PREPARED FOR NOELLE AND DOMINICK MARCHESE
**TREE MITIGATION PLAN SHOWING LOT 8, BLOCK 23
SULLIVANS ISLAND, TMS# 529-07-00-079**

Town of Sullivan's Island Building Department review - # P24-0286

MR. & MRS. MARCHESE RESIDENCE
2918 MIDDLE STREET
SULLIVANS ISLAND, SC

Proposed / demo ground floor plan
Scale 1/4" = 1'

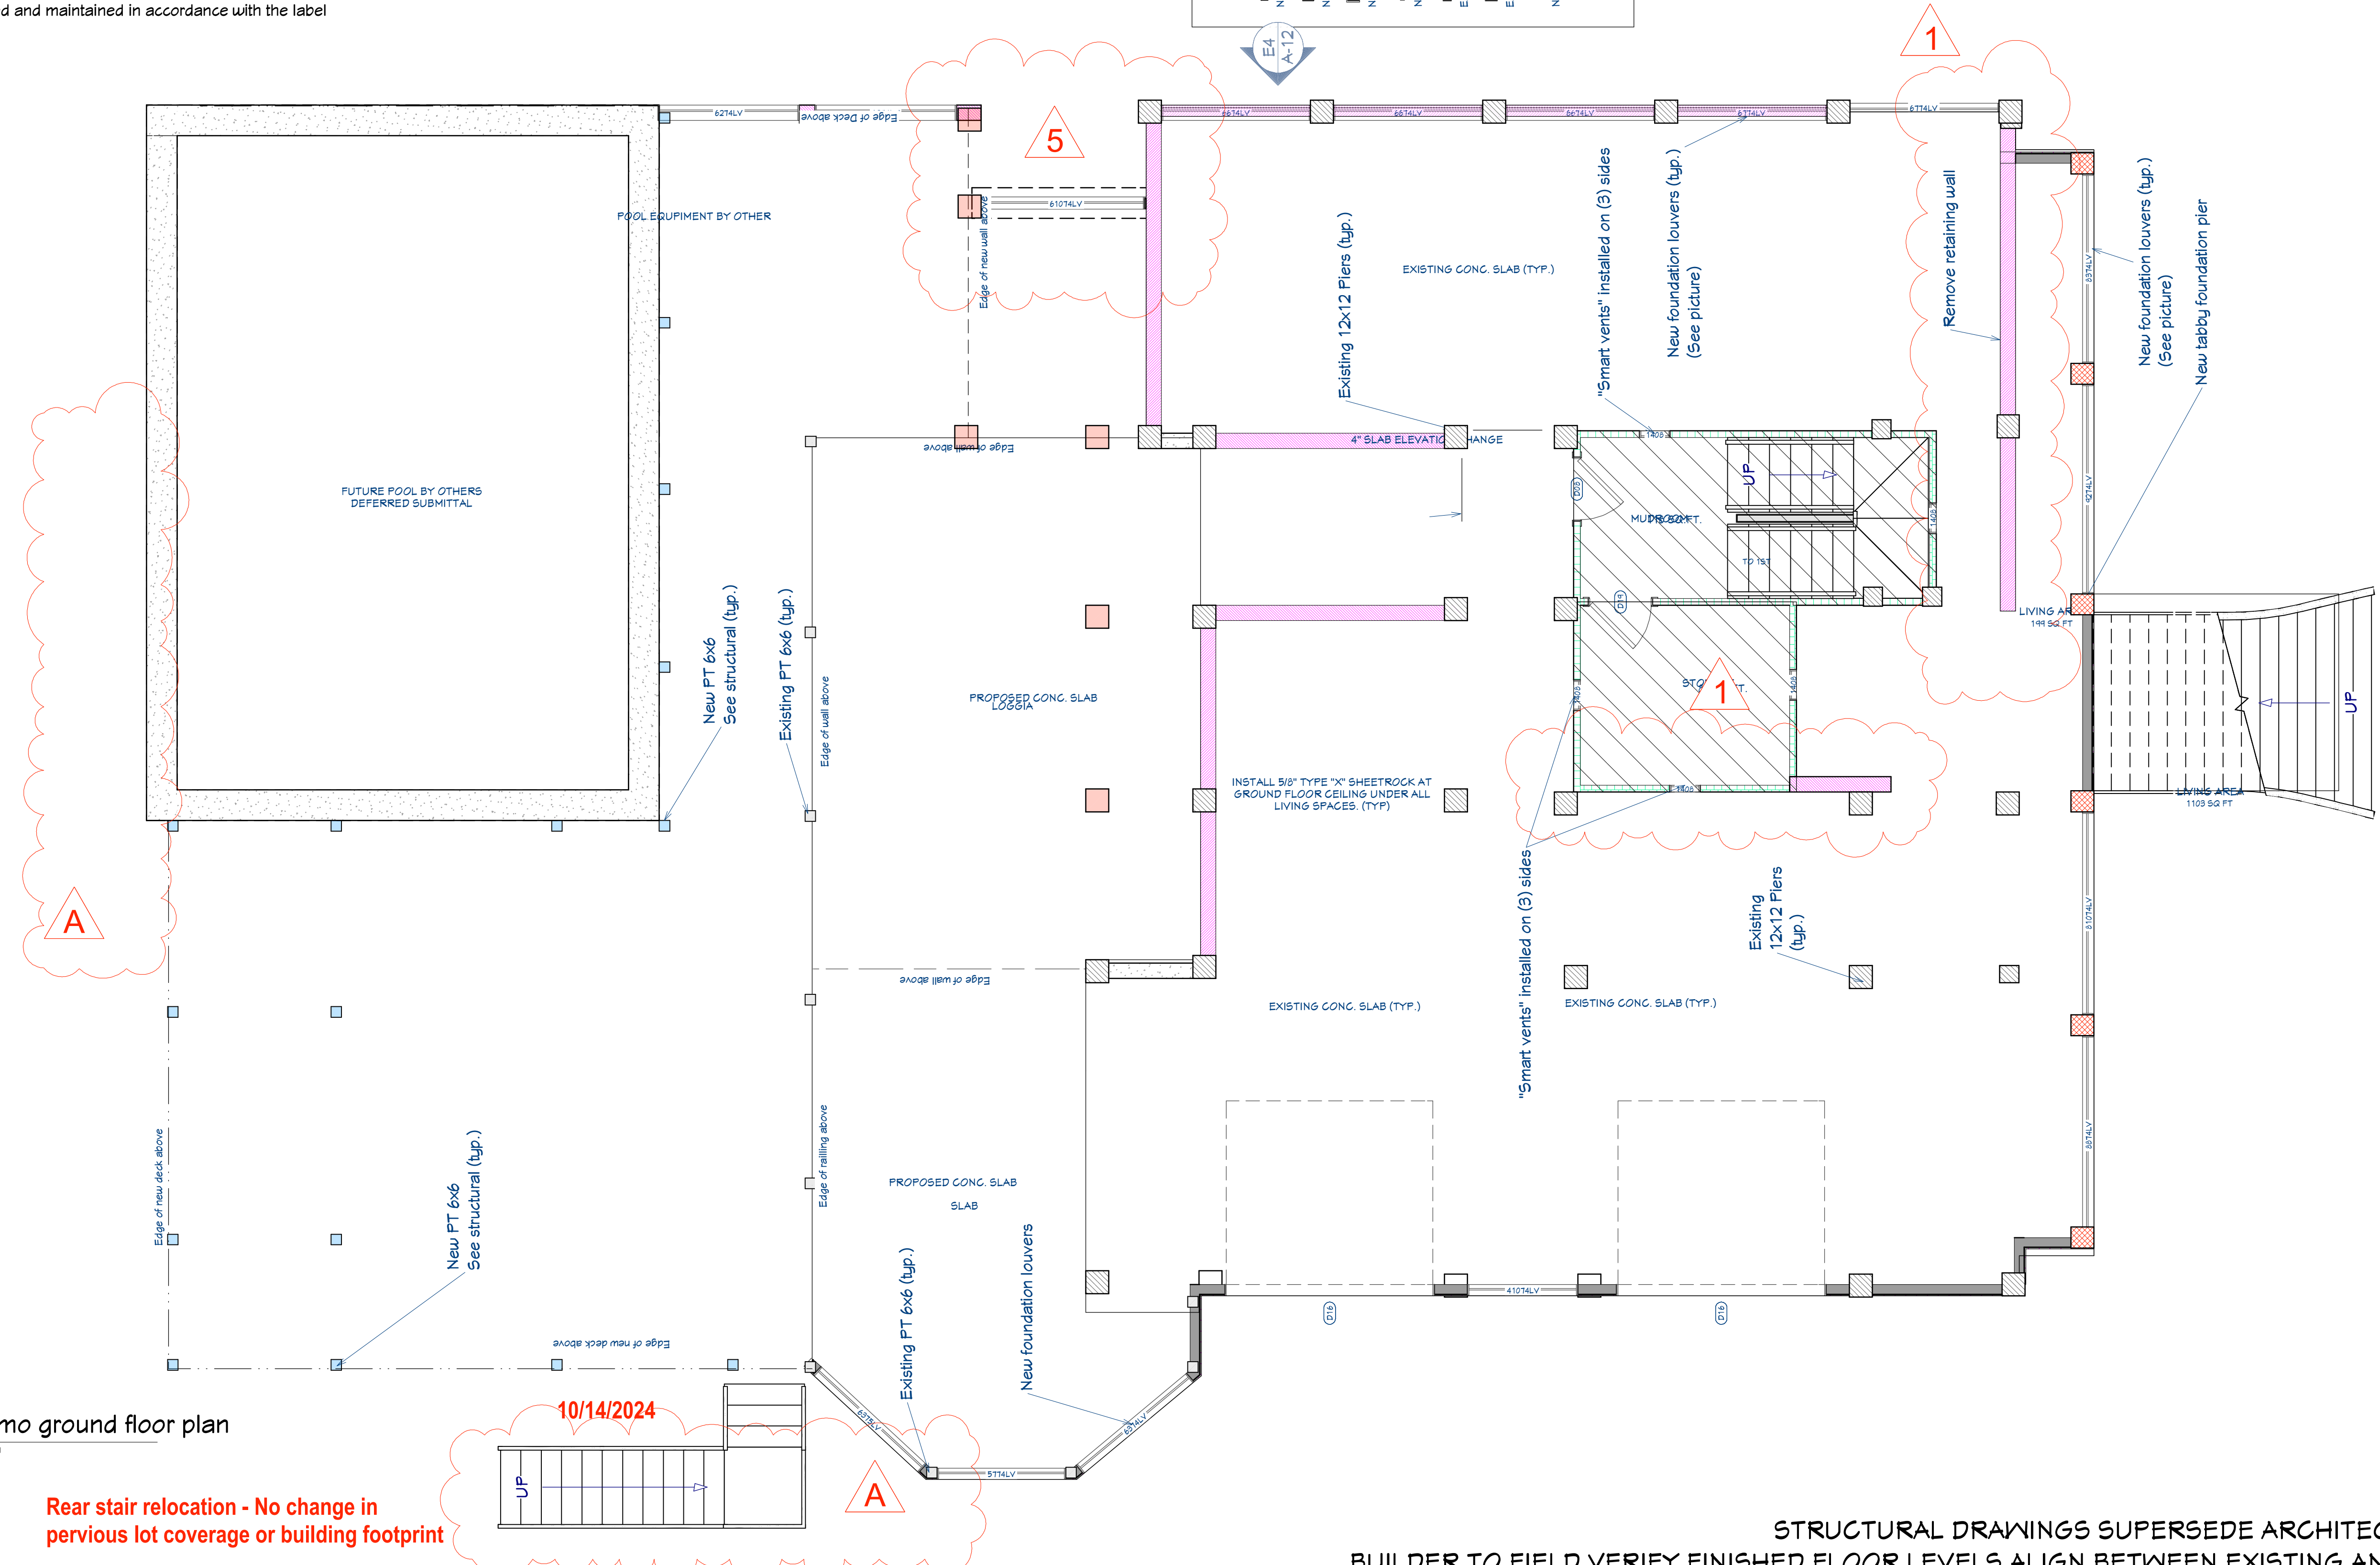
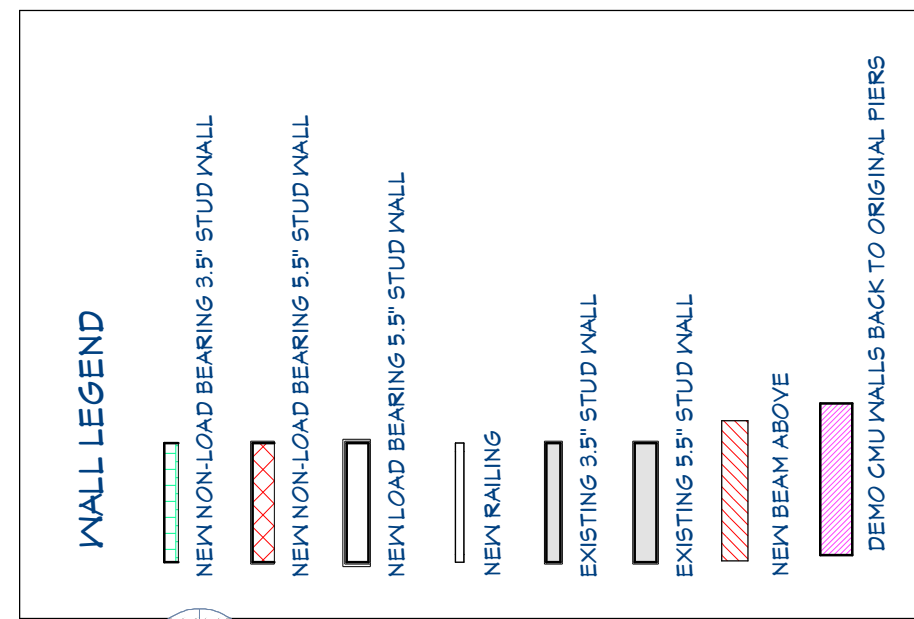
1. CMU Walls on front labeled "existing" were installed illegally and must be removed.
1. See Sheet A-6
2. No A zone design certifications on plans. Provide certifications.

Rear stair relocation - No change in pervious lot coverage or building footprint
